System Impact Assessment Report (Addendum)

Essa x Stayner 230 kV Transmission

CAA ID 2005-190

2008 February 12

Figure 3 -Proposed Change - New

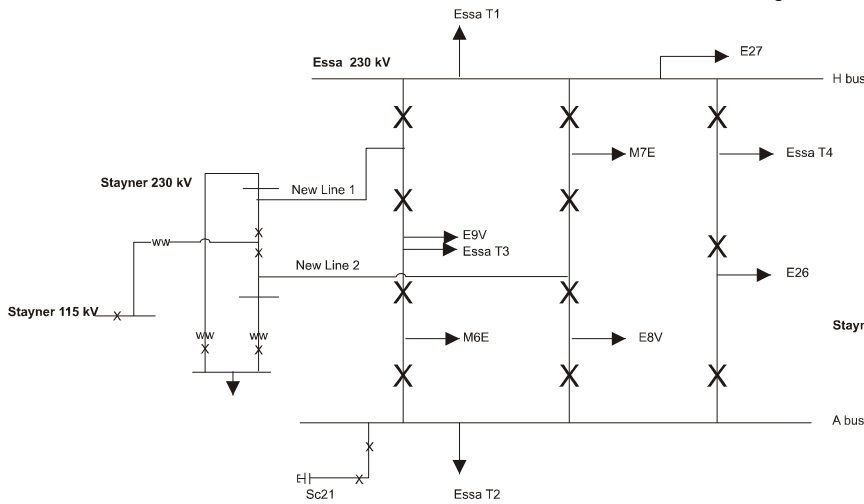
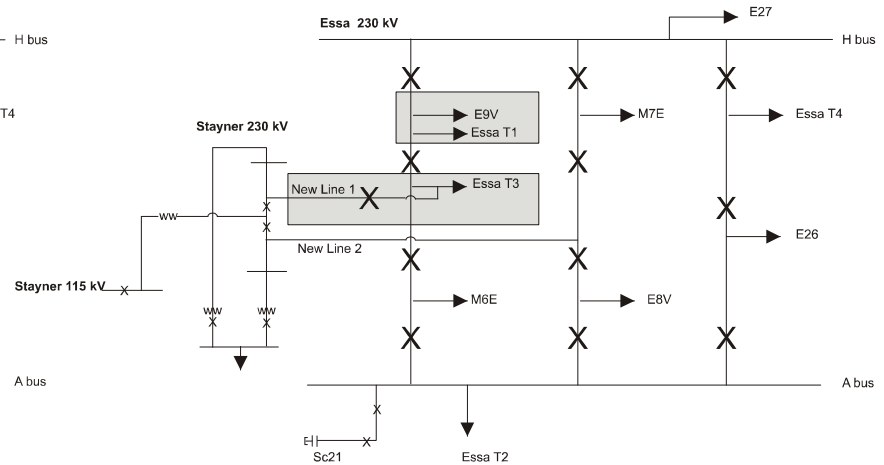
Recently, Hydro One has submitted a modified design of the Essa TS 230 kV station to the IESO. The modifications include:

- Reconfiguration of E9V, Essa T1, Essa T3 and Essa x Stayner 230 kV circuit
- Addition of an in-line breaker to one of the new Essa x Stayner 230 kV circuits

Figure 3 shows the proposed modified Essa TS 230 kV station configuration with the affected elements highlighted. **Figure 4** illustrates the new equipment associated with the additional in-line breaker.

The assessment of the Essa 230 kV switchyard re-configuration and new 230 kV in-line breaker concluded that:

- (1) The proposed changes will not have a material adverse effect on the IESO-controlled grid.
- (2) The new contingencies do not result in thermal overloading of the remaining lines.
- (3) The post-contingency voltages for the new contingencies were found to be within IESO criteria.

Figure 4 Addition of In-line Breaker at Essa x Stayner 230 kV Circuit

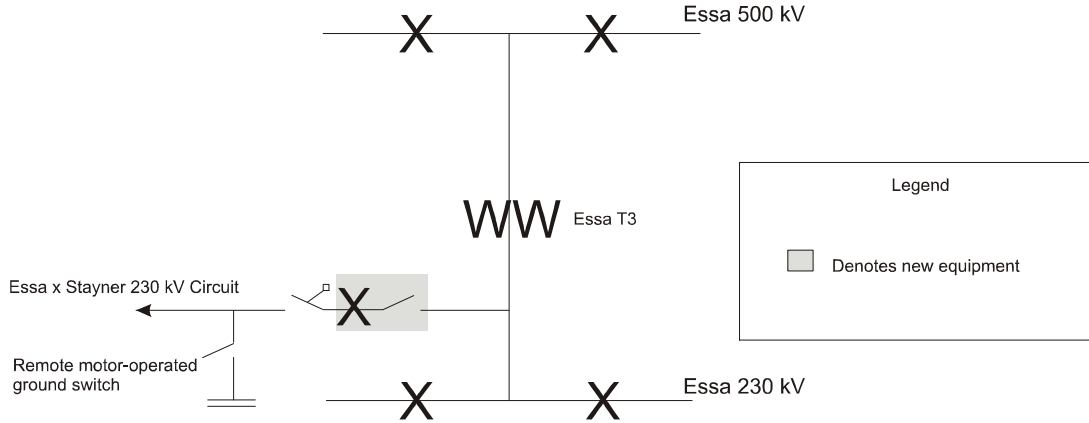
Specifications associated with the new in-line breaker and manual breaker switch provided by Hydro One are listed below. The in-line breaker is adequately rated, meeting the Transmission Code Requirement.

With respect to the addition of the in-line breaker, the IESO requires that:

- (1) The status of all isolating disconnect switches and breaker be monitored on a continual basis
- (2) The proponent must notify the IESO as soon as it becomes aware of any changes to the assumptions made in the connection assessment. The IESO will determine whether these changes require a reassessment.
